**To: Byron Shire Council  
Re: DA 10.2021.114.1  
FED SHEDS**

**Lot 10, DP 790630  
467 Federal Drive  
Federal NSW 2480**

**Submission to Byron  
Shire Council**

### **RE: DA 10.21.114.1 'FED SHEDS' at 467 Federal Drive, Federal.**

**Above are Drawings DA11 and DA50**

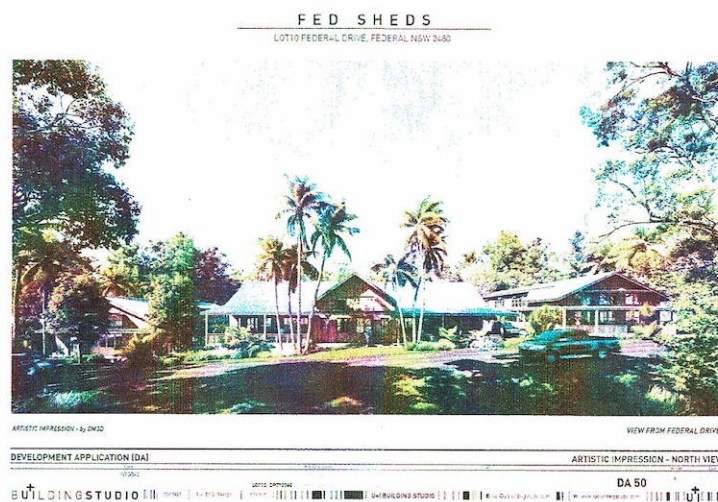
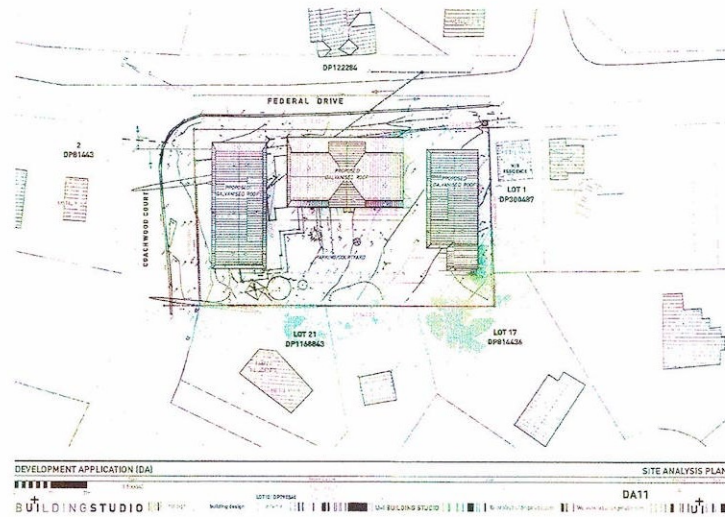
The drawing DA11 (see below) shows the roof plans of all the surrounding cottages and the heritage buildings, relative to the size of the roof plans of the proposed buildings. It also makes clear how close the proposed buildings are to each other. Drawing DA 50 (see below), the 'Artistic Impression, North View' is taken from an eye level that the buildings would never be seen from. A truthful rendering would show how the high open gables of the development would loom over the street.

This description in the HIA contradicts the reality of the bulk and scale of the proposal in comparison to the actual streetscape, but this description was not challenged by Council staff that were assessing the application. The community are concerned that Council staff did not take notice of the valid objections that were raised in the submissions against the proposal. The Staff Report 13.11 in the August 11th Agenda has five pages commenting on the submissions, all of which are dismissed using language from the reporting attached to the Development application.

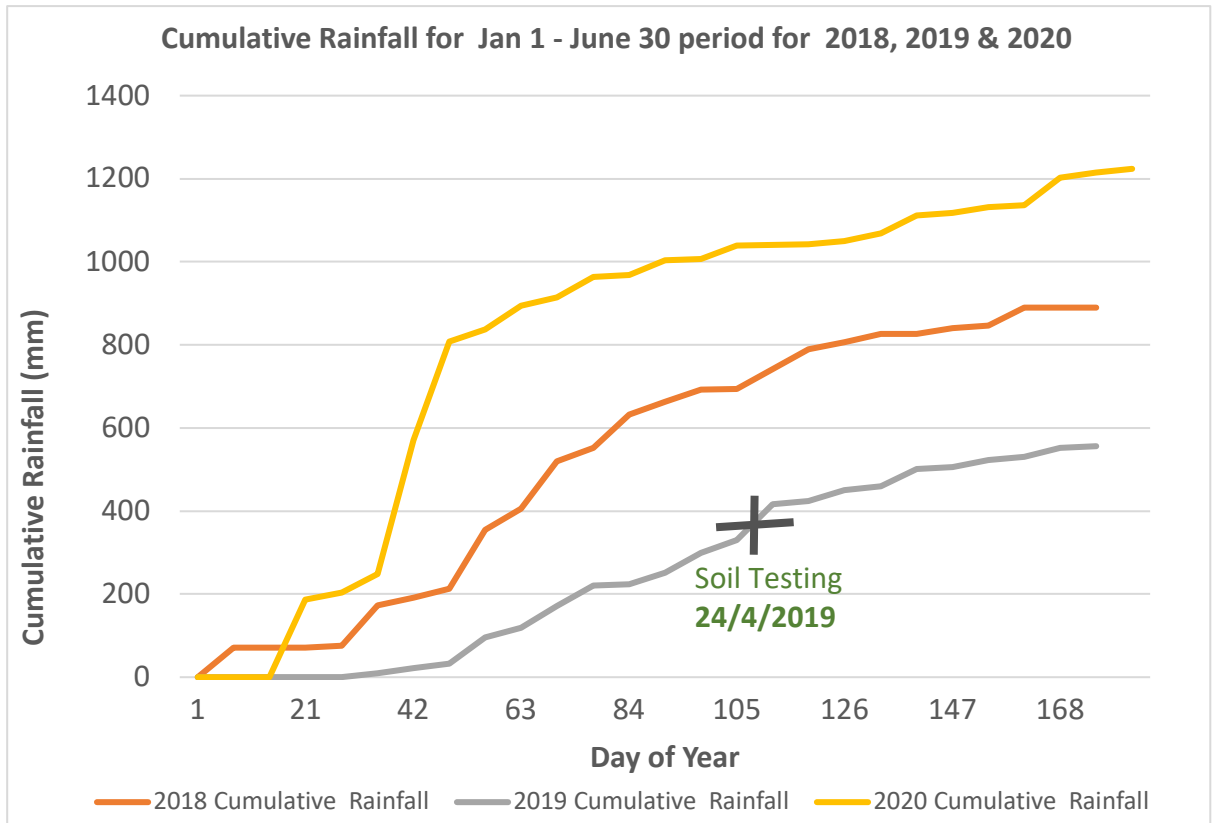
Ksat at FedSheds (GAA) is  $2.8 \times 10^{-6}$  to  $6.5 \times 10^{-7}$  m/s and thus, ALL values ( $2.8 \times 10^{-6}$  is also greater than  $1 \times 10^{-7}$  m/s !!!) are not accurate! See below extract from GAA.

McKenzie et al (2002) in chapter *Field Measurement of Saturated Hydraulic Conductivity Using the Well Permeameter* states that the Talsma-Hallam permeameter measurements are often one or two orders of magnitude less than determinations made with more accurate methods!

Thus, the land application area of 544 m<sup>2</sup> is not conservative, as based on above and thus, could well be a large factor too small.

“OSMS design model for households – not for commercial use(XLSM, 1MB)”

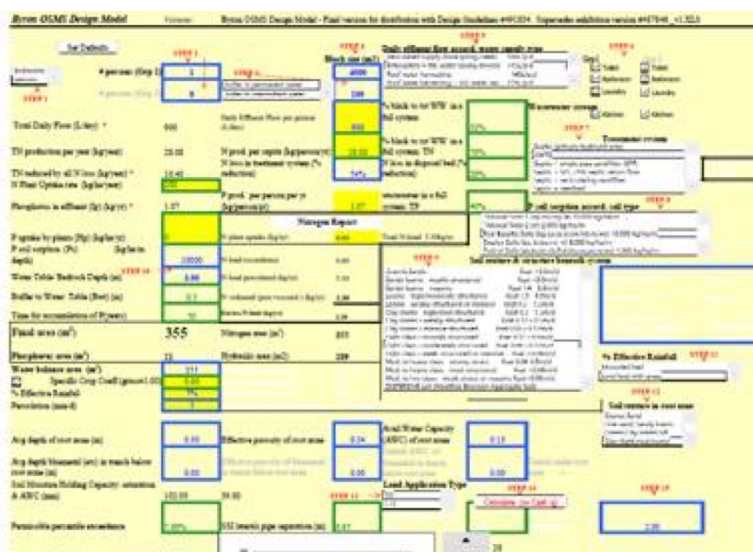
6. **Byron OSMS Design Model used by [GAA1&2] is not applicable**, as [BSC3] explicitly says that this model is ‘for household design, not commercial designs’. The model printout in the DA shows 1-bedroom single household. It also uses Ksat value that is thought too high while uncertain making the application area too small.

GAA has used 0.06 – 0.12 m/d (light clays moderately structured) in the model. Talsma-Hallam method as per GAA gives (see above) 2.8E-6 to 6.5E-7 m/s range which is 0.24 – 0.05 m/d for bore-cores
